UNITED STATES PATENT AND TRADEMARK OFFICE

APPLICATION NO.	FILING DATE	FIRST NAMED INVENTOR	ATTORNEY DOCKET NO.	CONFIRMATION NO.
10/791,101	03/02/2004	Shimshon Gottesfeld	107044-0043	2480
24267	7590	05/18/2007		
CESARI AND MCKENNA, LLP 88 BLACK FALCON AVENUE BOSTON, MA 02210			EXAMINER CANTELMO, GREGG	
			ART UNIT 1745	PAPER NUMBER
			MAIL DATE 05/18/2007	DELIVERY MODE PAPER

Office Action Summary	Application No. 10/791,101	Applicant(s) GOTTESFELD ET AL.	
	Examiner Gregg Cantelmo	Art Unit 1745

DETAILED ACTION

FIG. 4

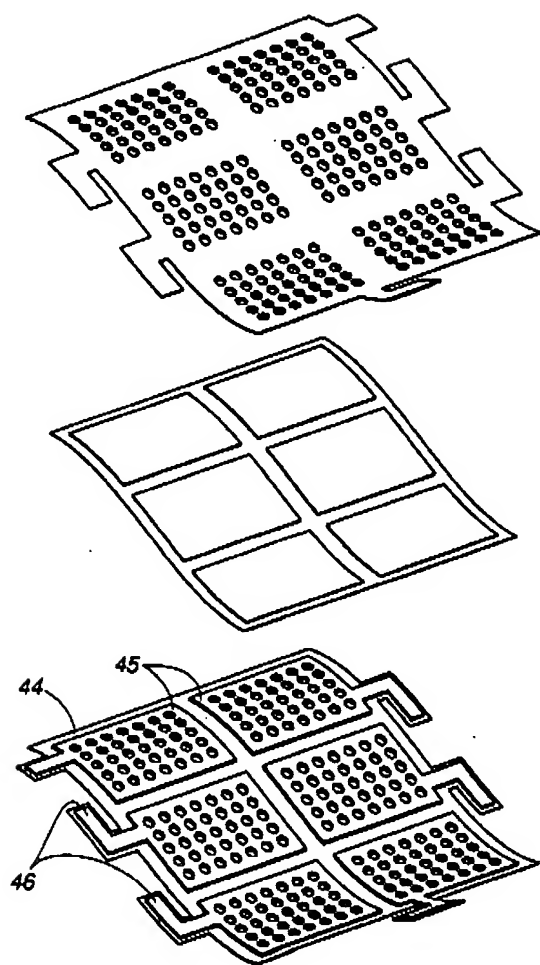
Pratt discloses a conformable fuel cell in Fig. 4, comprising: (A) a membrane electrolyte intimately interfacing with a catalyst layer along each of the membrane's major surfaces being a catalyzed membrane electrolyte, having an anode aspect and a cathode aspect, and which catalyzed membrane electrolyte is flexible (e.g., conformable to a desired shape); (B) diffusion layers sandwiching said catalyzed membrane electrolyte, said diffusion layers being comprised of materials that are conformable; (C) flexible current collectors coupled with each of said anode aspect and said cathode aspect of said membrane electrolyte; (D) fuel delivery means coupled with said anode aspect of said membrane electrolyte that delivers fuel substantially uniformly to said anode aspect while said fuel cell maintains said desired shape (Figs. 2-5); (E) electrical coupling 45 disposed across said anode aspect and said cathode aspect and having means for connection to an application device being powered by said fuel cell (as applied to claim 1).

The current collectors 45 at each of said anode aspect and said cathode aspect apply “adequate compression” effectively over the active area of the membrane electrolyte of each cell (Fig. 4 as applied to claim 2)

The fuel cell in Fig. 4 is shaped to form a curvilinear shape (col. 5, ll. 25-28 as applied to claim 12).
